Addendum ADD#3

Date: June 10, 2026
Project Name: Verona Housing
Project Address: 6094 Carleton Dr, Verona, ON K0H 0B8
Project Number: 26001

Structural Addendum #2

M030

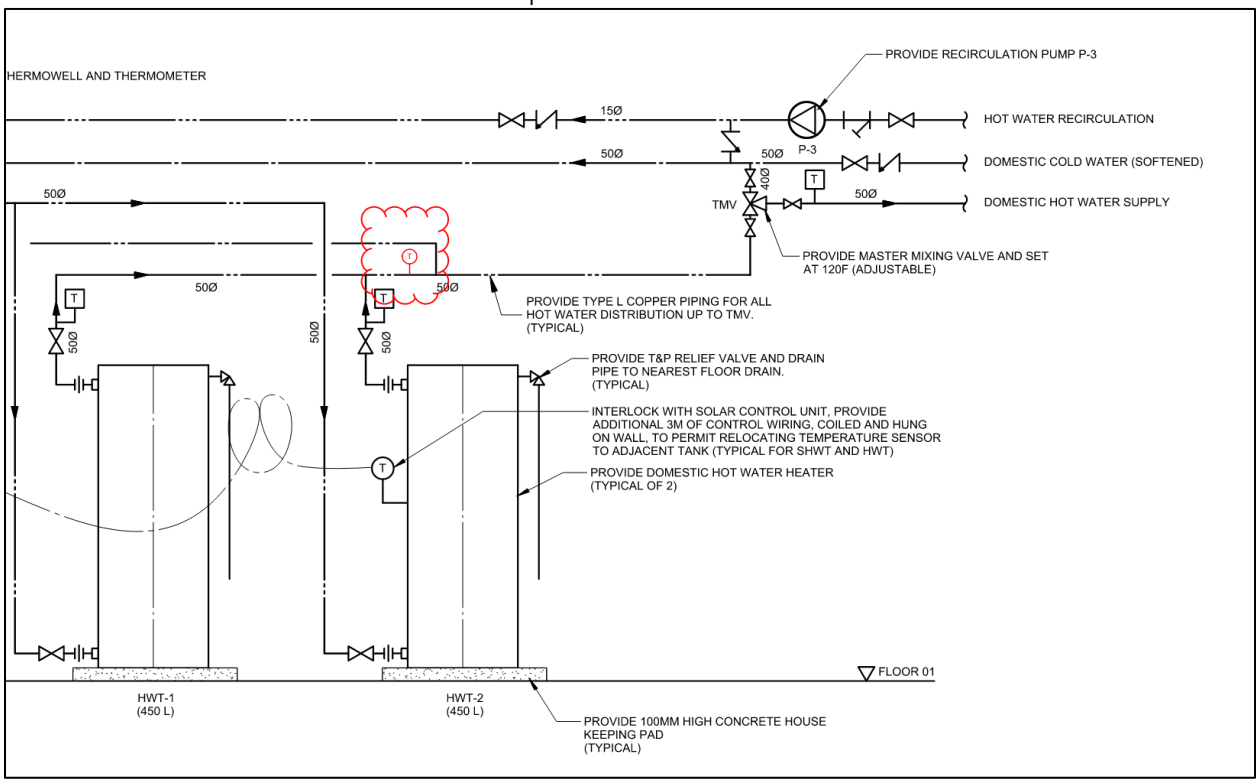
- Provide additional thermowell and temperature sensor as indicated.

SHEET NUMBER: A004

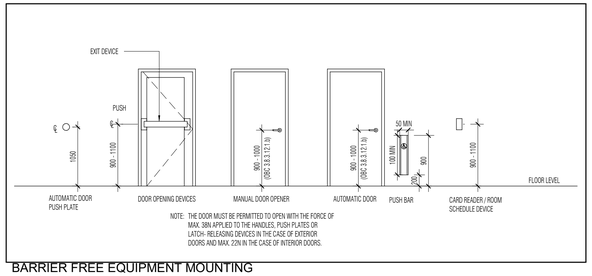
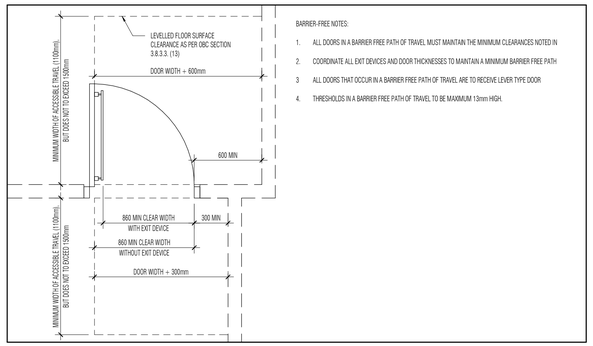
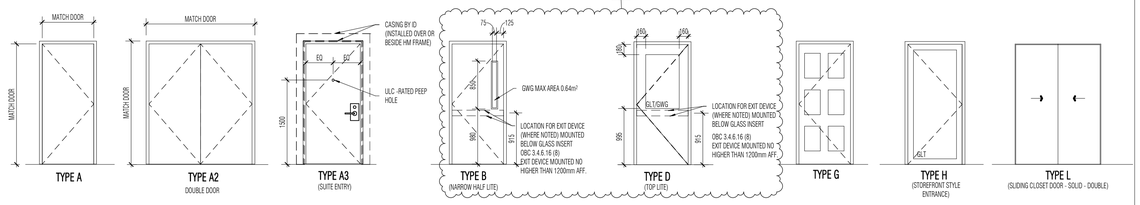
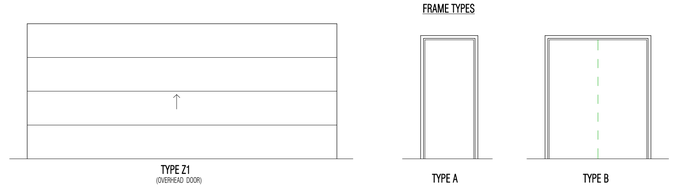
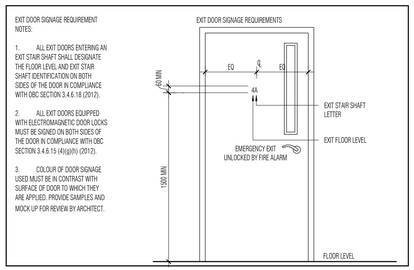
2. **Description**
   a. A001.1: Shaft wall assembly ‘SW1’ has been removed.
   b. A004: Push-button and automatic door openers have been added to Doors D102, D103, D116, D117, and D120.

c. A004: Exit device hardware has been removed from Doors D102, D103, D120, and D123.
   d. A004: D109 door material is changed to HM/GWG.
   e. A004: Door frames for T01 and T02 have been revised to hollow metal (HM), and the door stain has been updated to match PT5.

f. A004: Door Type ‘B’ and ‘D’ dimensions are updated.
   g. A201: In Card Room 012, the corridor wall has been relocated, and the door swing has been revised to swing outward.

SHEET NUMBER:
A201

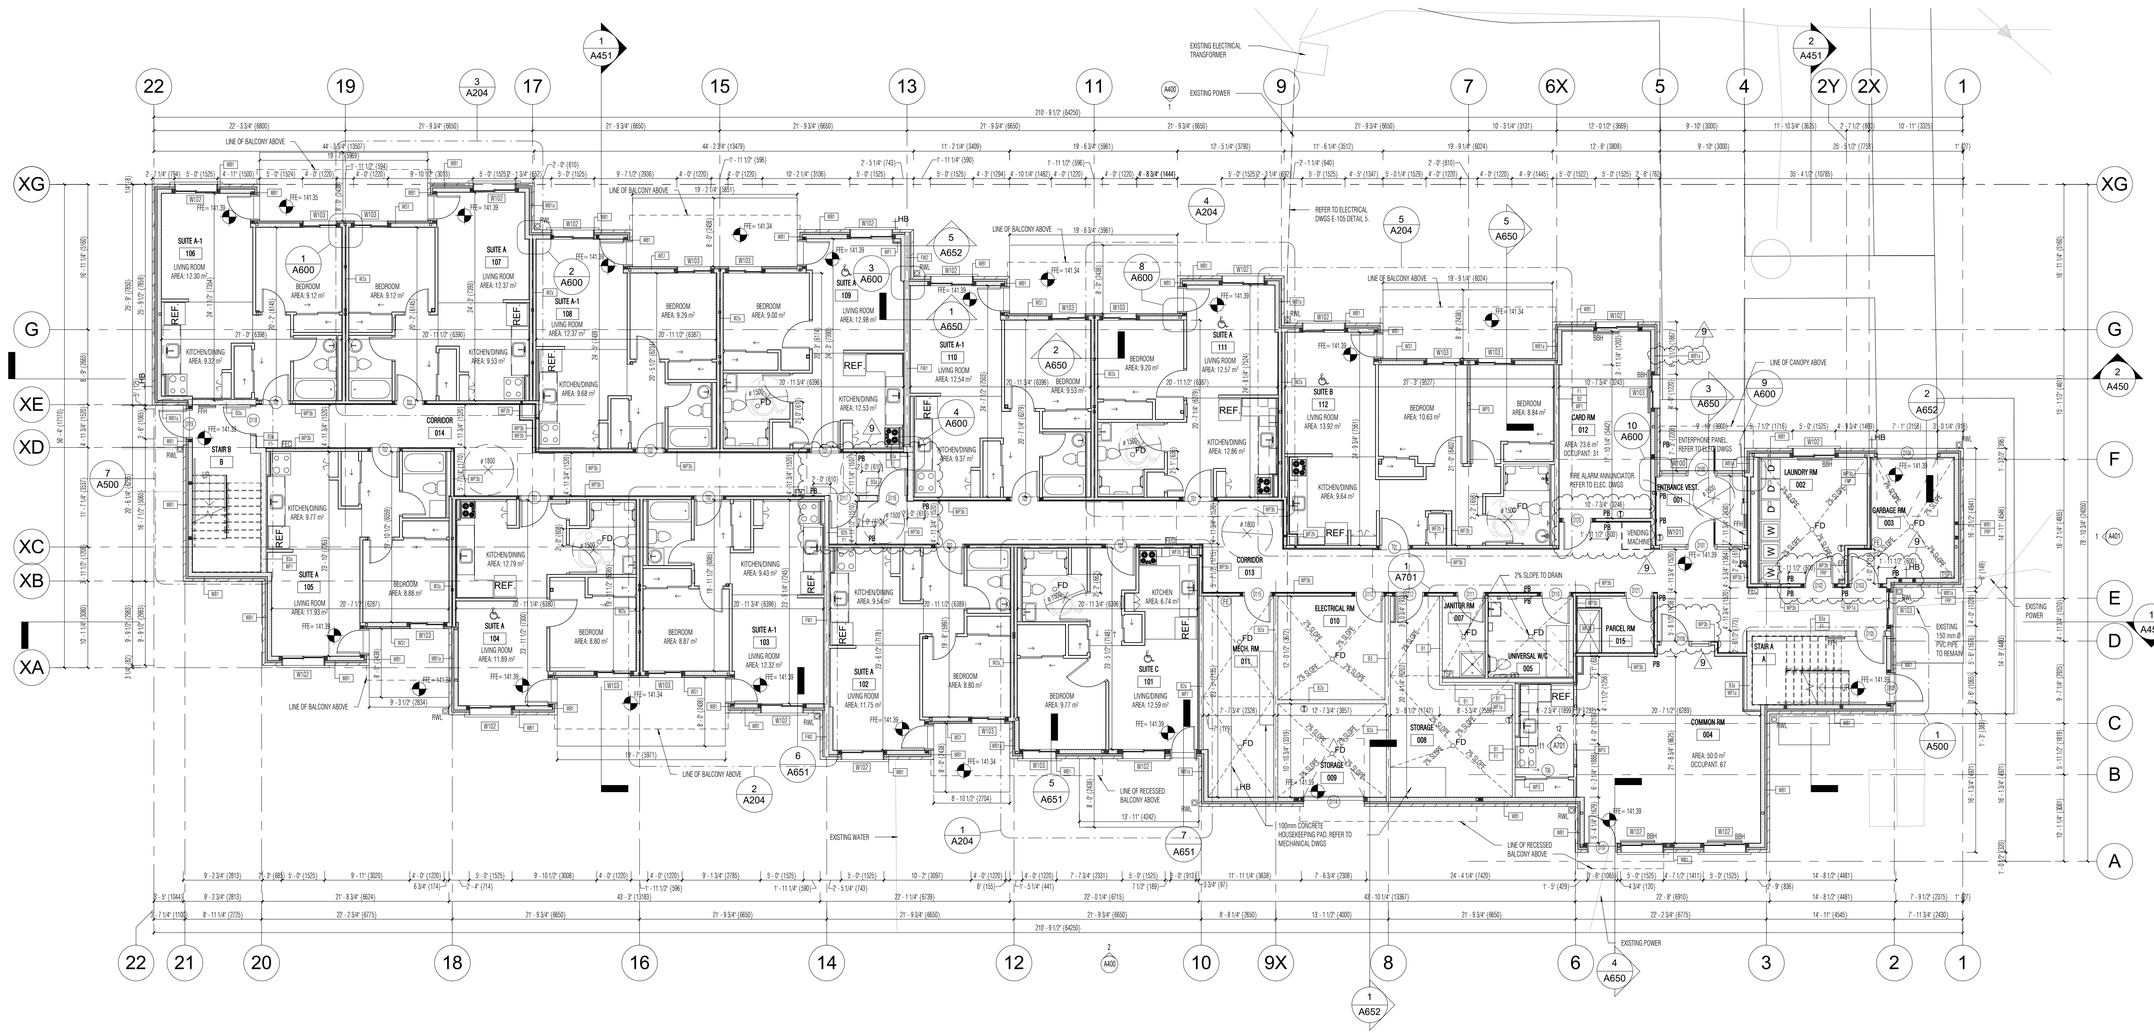
h. A201: In Common Rm 004, the corridor door is mirrored and revised to swing outward.
   i. A201: The exterior wall on the west side of the entrance has been revised to Wall Assembly ‘WB1a’.

SHEET NUMBER:
A400

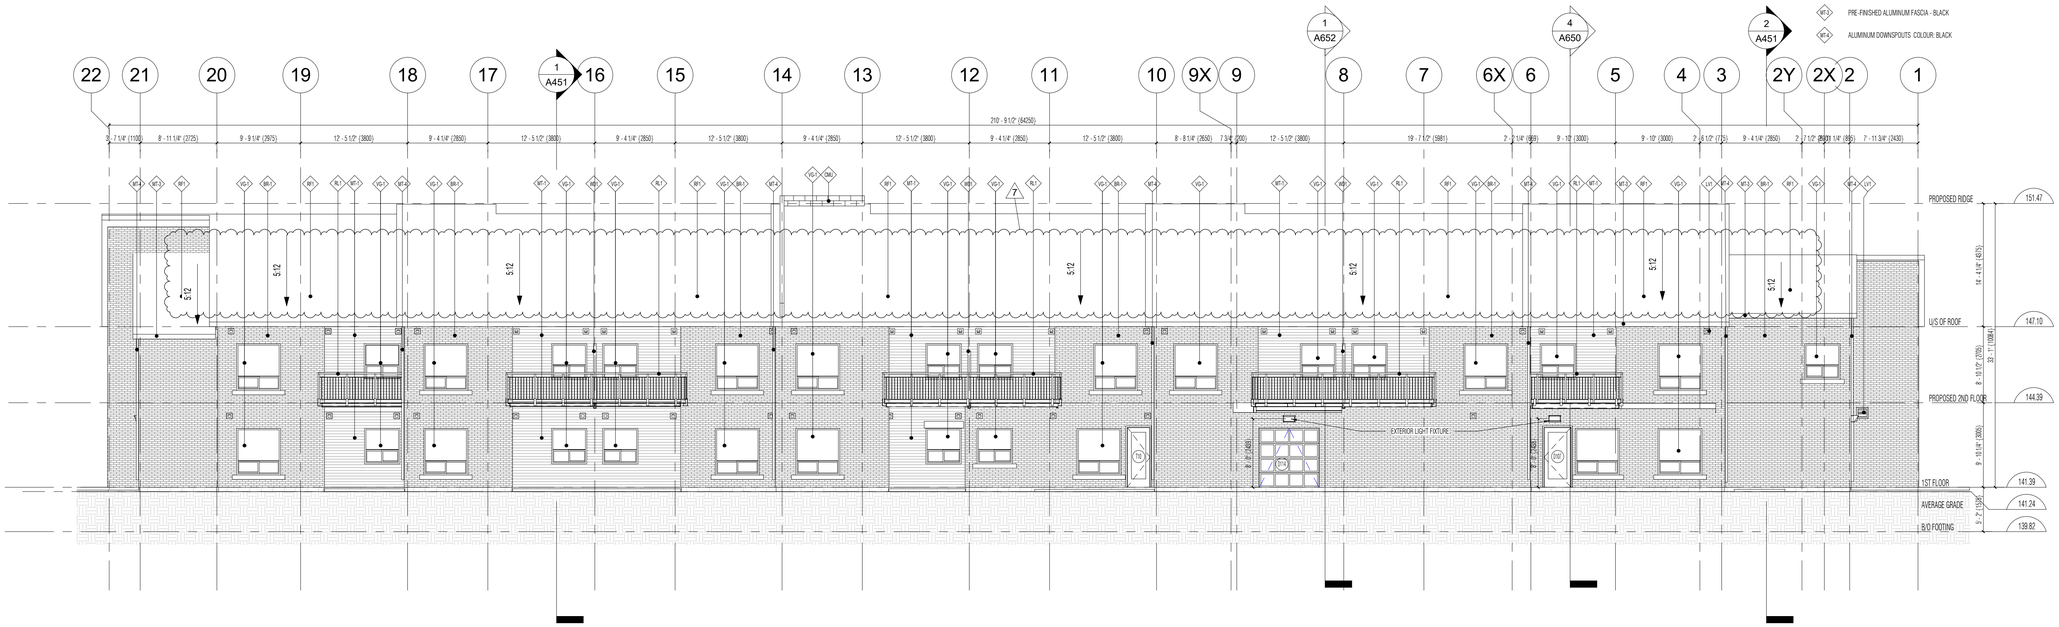
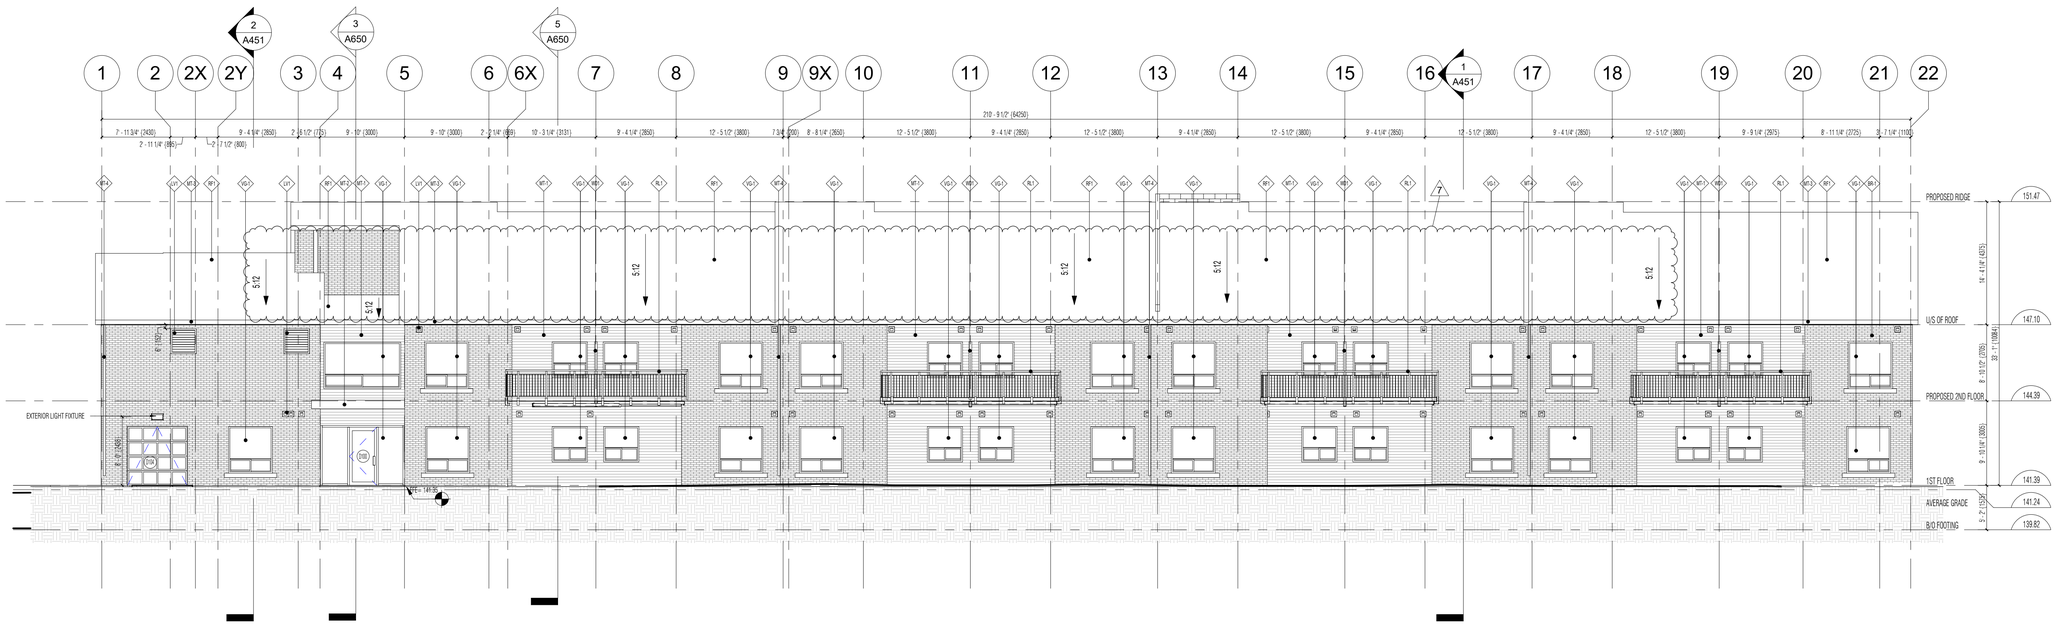
j. A400 and A401: Roof slope added to the elevations.
   k. A650, Detail 2: Fire-rated sealant added to the roof and wall stud.
   l. A651, Detail 5: The metal flashing at the underside of the window sill has been removed.

SHEET NUMBER:
A702

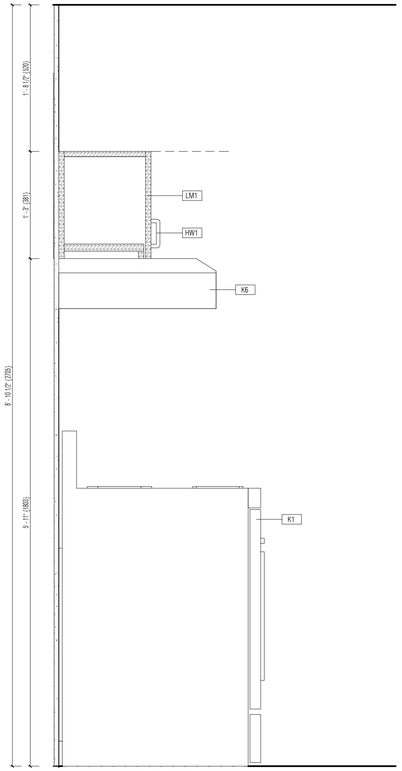
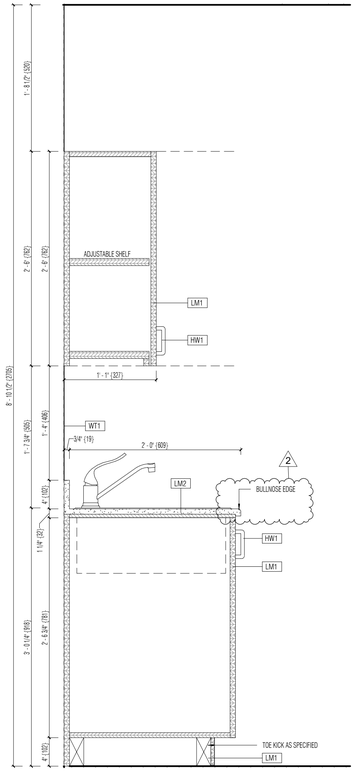
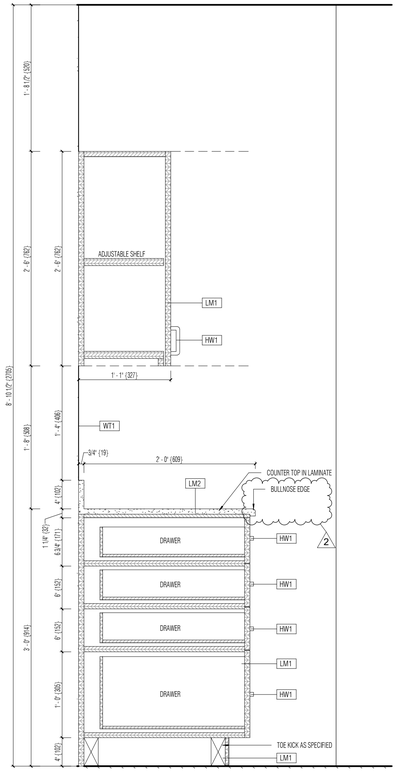
m. A702: The laminate countertop edge profile has been revised to a bullnose edge.

Client	Kingston Frontenac Housing Corp.
Address	6094 Carleton Drive, Verona, ON
File	25-10031PR
Title	Structural Plans
Sheet	S4-100

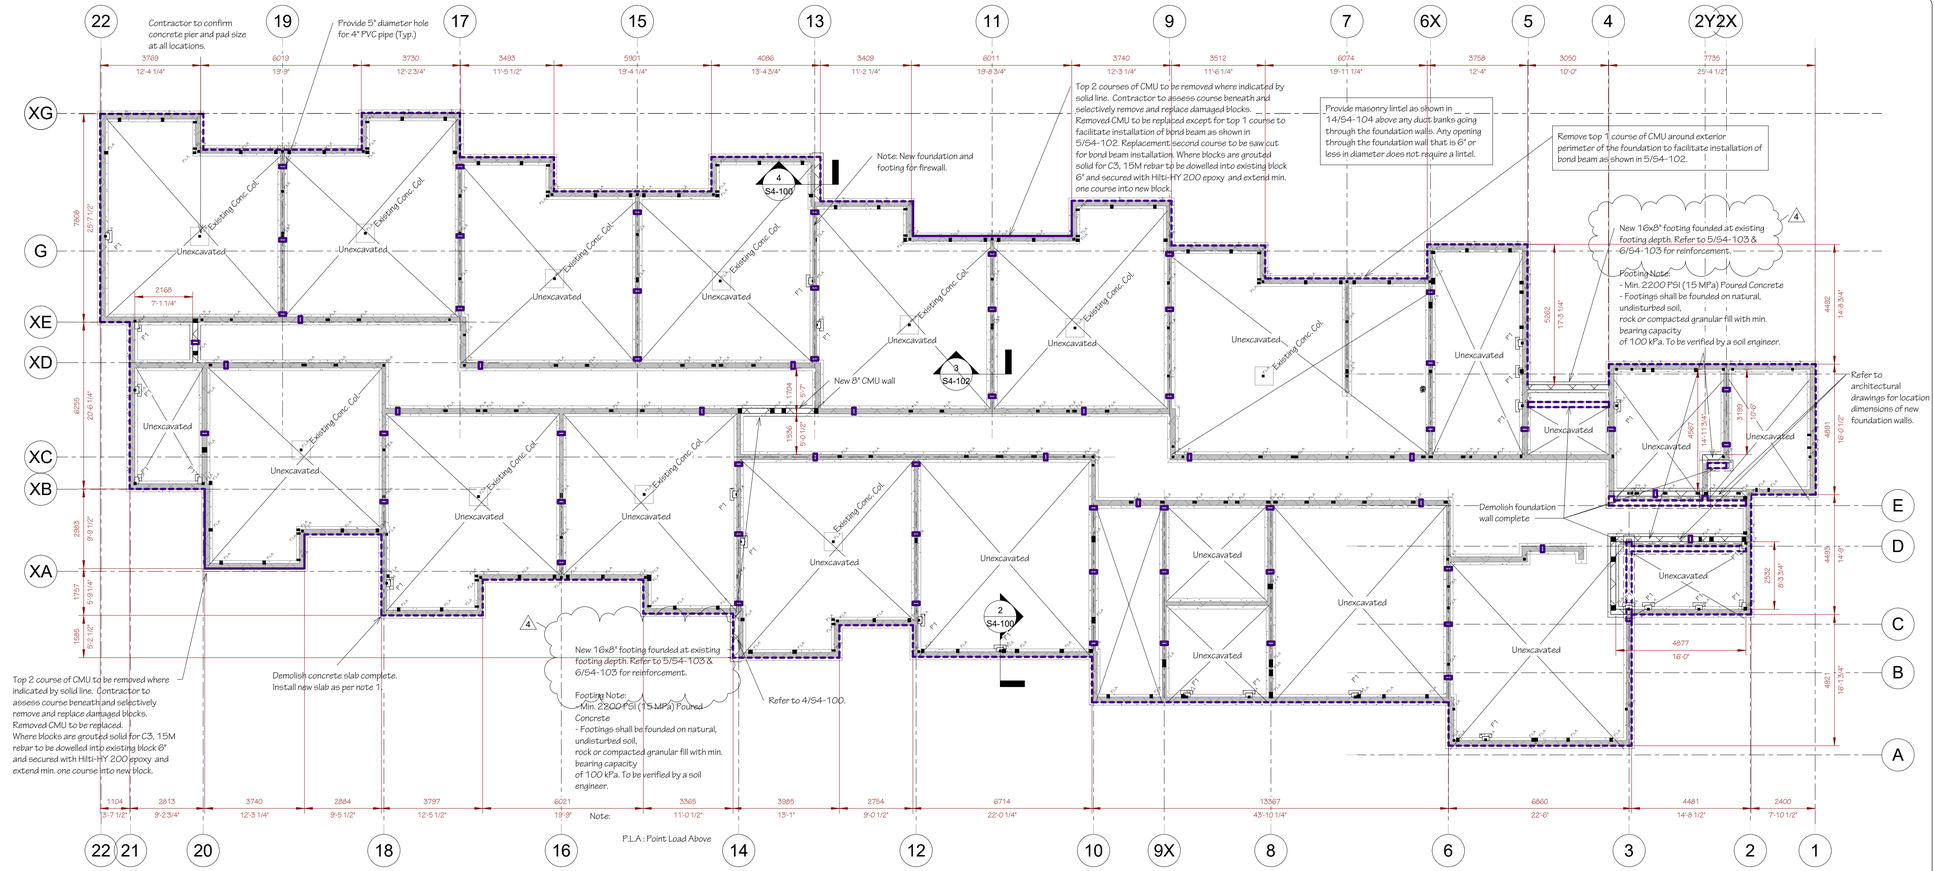
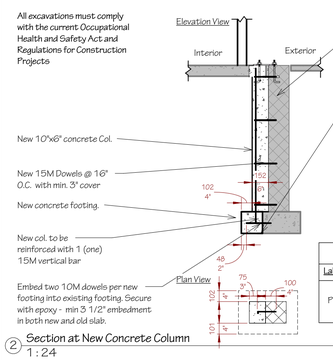
S4-100

- Updated note to reference the details 5/S4-103 and 6/S4-103 for the CMU and footing reinforcement for the new foundation walls.
- Included dead load of solar panels in design load notes.
- Provided framing dimensions.

7 Detail, Beam with Plate Not Centered
1 : 12

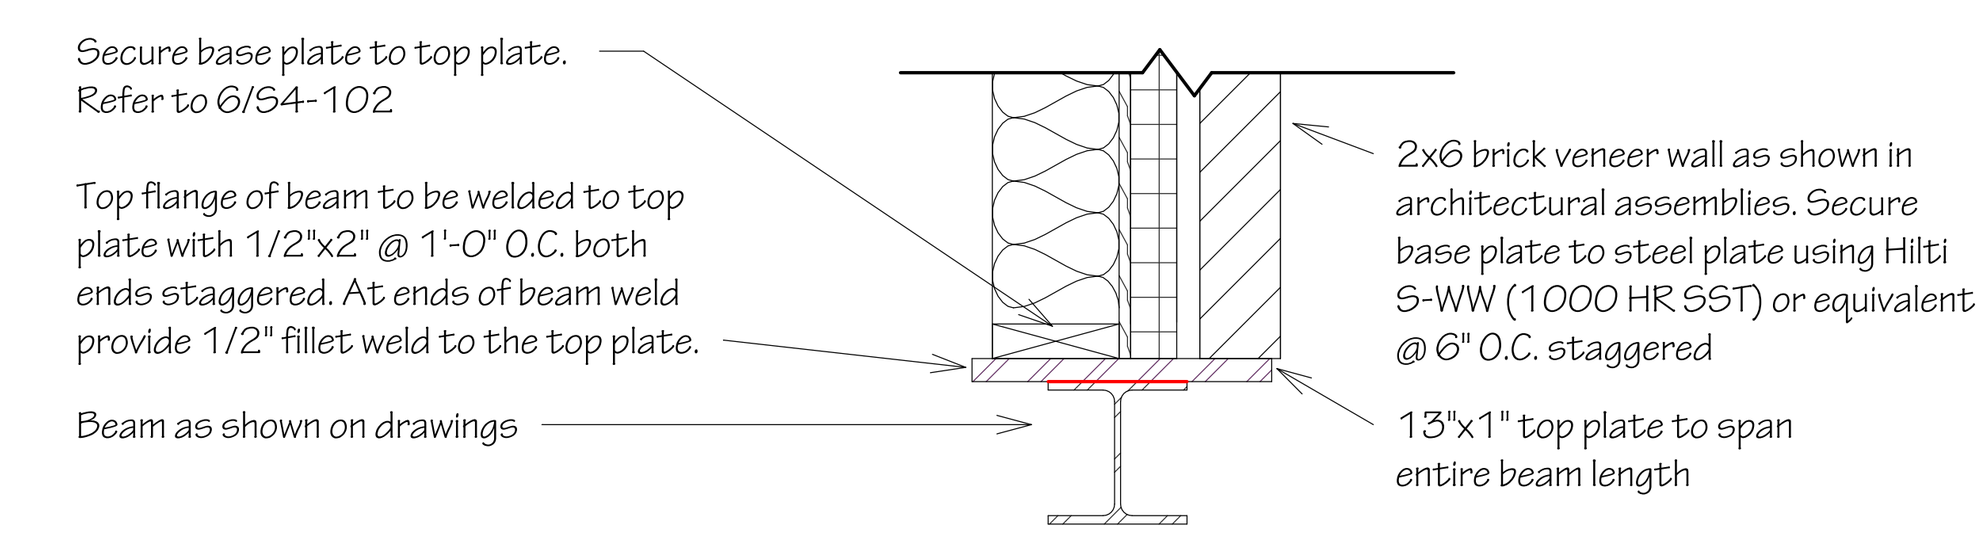
- Provided detail for beam plate connection to provide adequate bearing for the wall above in the re-framed 3-6 gridling rear balcony as shown in 7/S4-102.
- Provided framing dimensions.
